Entergy Nuclear Operations, Inc.
Pilgrim Station
600 Rocky Hill Road
Plymouth, MA 02360

SUBJECT: Entergy Nuclear Operations, Inc.
Pilgrim Nuclear Power Station
Docket No.: 50-293
License No.: DPR-35

License Renewal Application Amendment 4:
Response to Request for Additional Information
Regarding Severe Accident Mitigation Alternatives for
Pilgrim Nuclear Power Station (TAC NO. MC9676)

Response to Request for Additional Information Regarding SAMAs

Figure RAI.2-1 Level I-to-Level II Interface Logic Tree

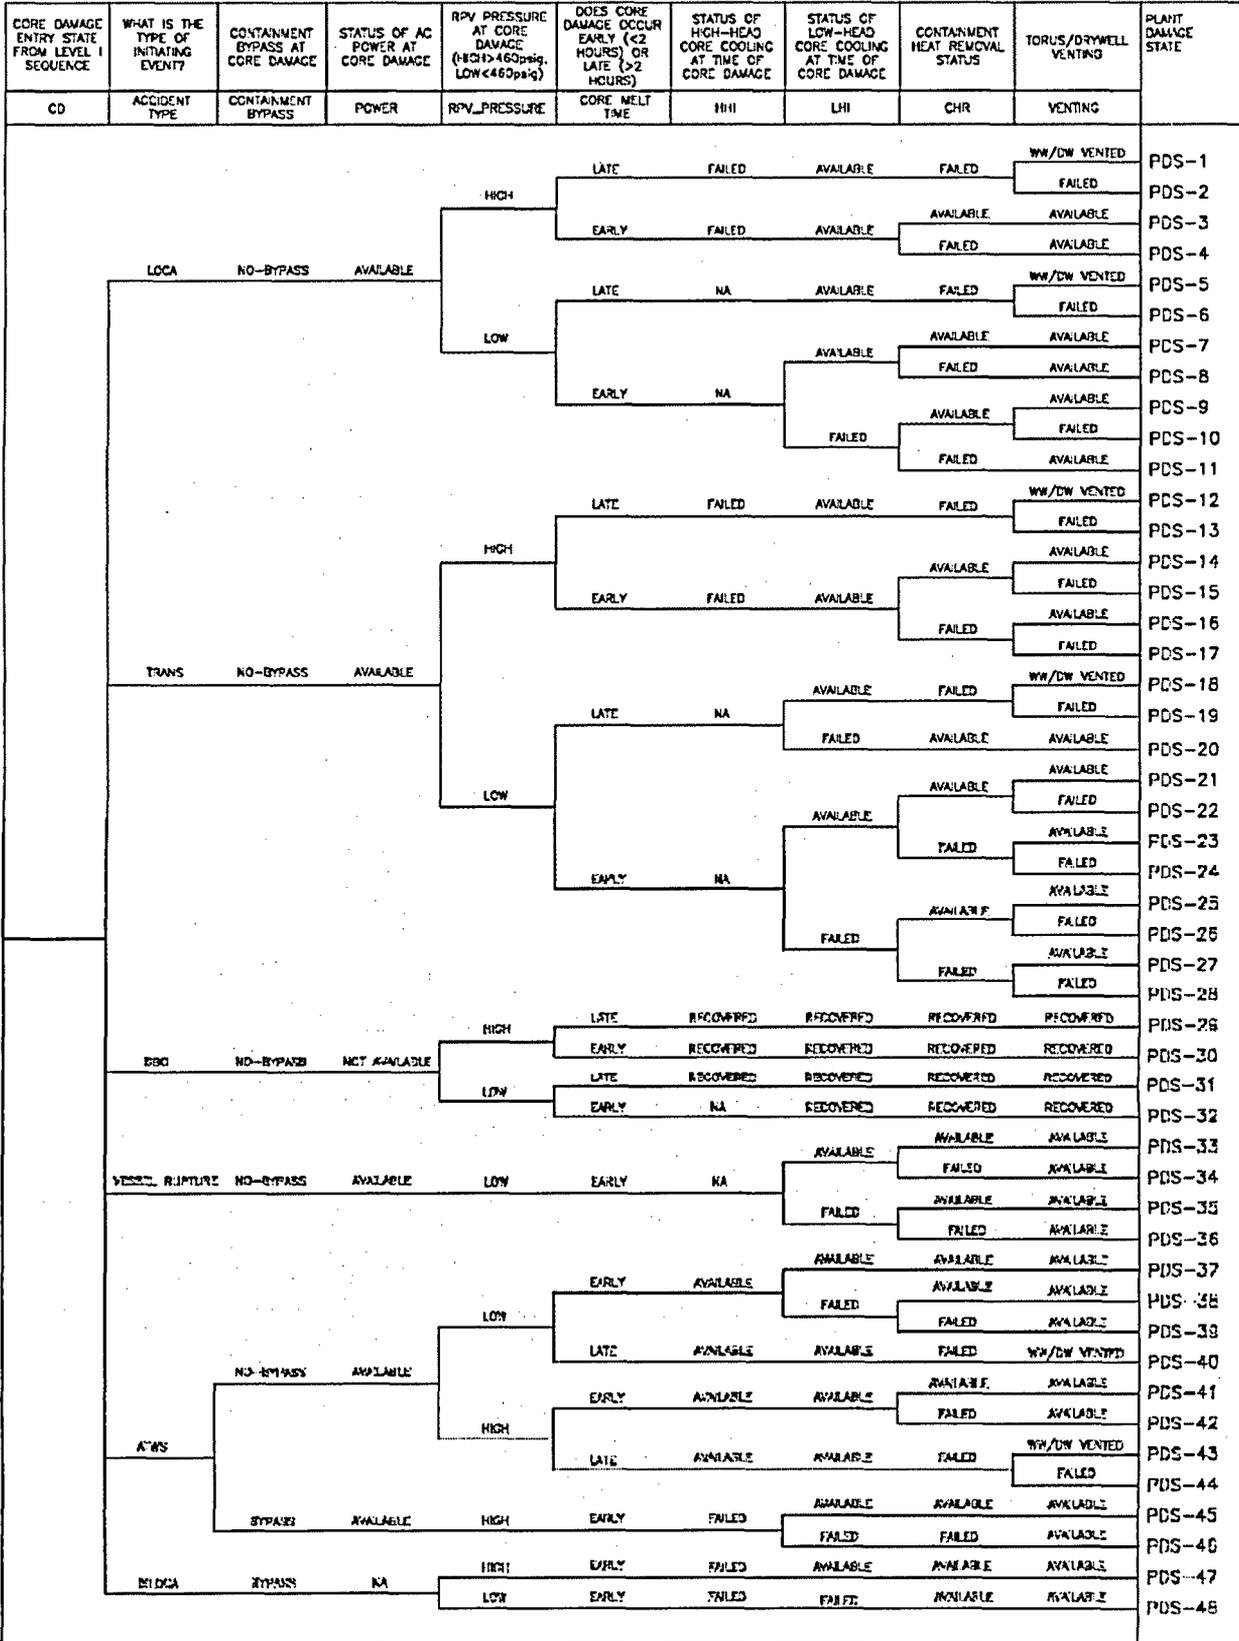
- a. In ER Section E.1.2.2.1 it is stated that "The Level 1 and plant system information is passed through to the [containment event tree] (CET) evaluation in discrete [plant damage state] (PDS)." ER Table E.1-4 identifies seven PDS groups and ER Table E.1-8 identifies 48 more detailed PDSs. It is noted that for certain PDSs, the frequency in the Table E.1-4 does not equal the sum of the frequencies for like-PDSs in Table E.1-8. Provide a description of the mapping of Level 1 results into the various containment end states/release categories, and the relevance of the PDS as input to the CET. Address whether the PDSs uniquely define failed equipment for the CET analysis or whether this is done by inputting the cutsets. Also, discuss whether the sequences that make up a PDS are combined and entered into the CET as a frequency, or whether the cutsets that make up each group of core damage sequences are entered into the CET, and the relevance of the two inconsistent sets of frequency values in Tables E.1-4 and E.1-8.

Based on these criteria, a Level 1-to-Level 2 interface event tree was developed. Figure RAI.2-1 depicts the selected PDS binning attributes. This event tree also serves as the template for sorting individual Level 1 sequences into the appropriate plant damage states. Each sequence is characterized by a set of conditions which define a unique plant damage state.

The PDS frequency is represented by the total frequency of those Level 1 sequences that satisfy the PDS binning criteria shown in Figure RAI.2-1. For example, from the updated PSA, sequence A-3 is a large LOCA sequence that results in core damage due to failure of low-pressure injection systems LPCI and core spray. This sequence satisfies PDS-7 attributes: LOCA initiator, low vessel pressure, early core damage, and the availability of alternate low-pressure injection systems (firewater), containment decay heat removal (torus cooling, etc.) and torus venting.

The input to the containment event tree (CET) is the PDS frequency and different flag settings based on the PDS definition as depicted in Figure RAI.2-1. Hence, the CET outcome represents the unique accident progression for that PDS.

Figure RA1.5-2 PNPS Direct Torus Vent Pathway

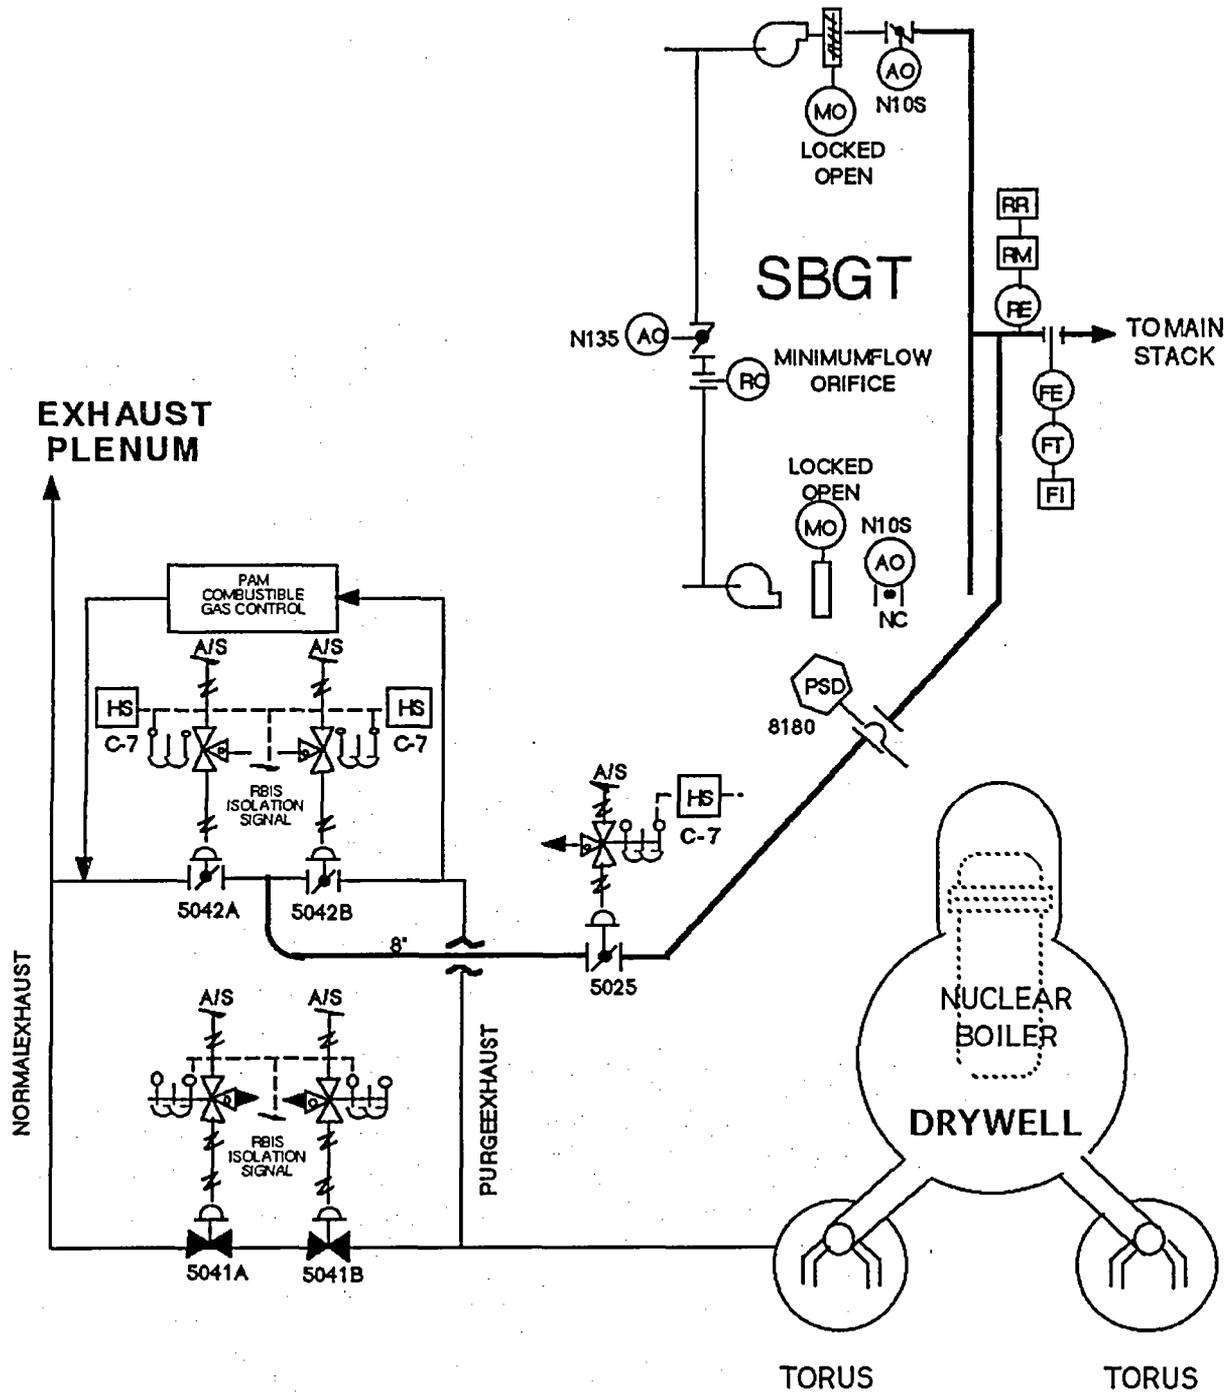
in the basic event. Conversion of the containment vent system to a passive design would appear to be more effective in reducing the risk from this event. Provide an evaluation of the costs and benefits of converting the vent system to a passive design.

- h. Phase II SAMA 53 proposes a method to control containment venting within a narrow band to preclude net positive suction head concerns for pumps taking suction from the torus. The evaluation for SAMA 53 considered a reduction in the probability of failure to perform direct torus venting when required. Since SAMA 53 does not directly address plant operators failing to vent containment, a new SAMA is proposed to evaluate the cost benefit of a passive design direct torus vent instead of the existing direct torus vent.

The existing direct torus vent line originates downstream of torus purge exhaust isolation valve AO-5042B and aligns flow to the normally-closed direct torus vent isolation valve AO-5025 (see Figure RAI.2-2). Downstream of AO-5025, the vent line continues to rupture diaphragm PSD-8180. Torus air space pressure must be greater than or equal to 30 psig in order to break the rupture disc associated with this vent path. After rupturing PSD-8180, flow from the direct torus vent line passes to the common outlet from both standby gas treatment trains and proceeds to the main stack. Air operator valves AO-5042B and AO-5025 and associated solenoid valves are controlled from the control room. These valves need 125-VDC power and an air or nitrogen supply to open. They fail closed on loss of air and nitrogen or on loss of power.

Conversion of the existing direct torus vent to a passive torus vent resulted in a CDF reduction of 14.5 percent benefit and a revised baseline with uncertainty benefit of approximately \$1,152,242. The cost of changing the direct torus vent to a passive design is estimated to be \$3,161,837. Therefore, this SAMA is not cost effective for PNPS.
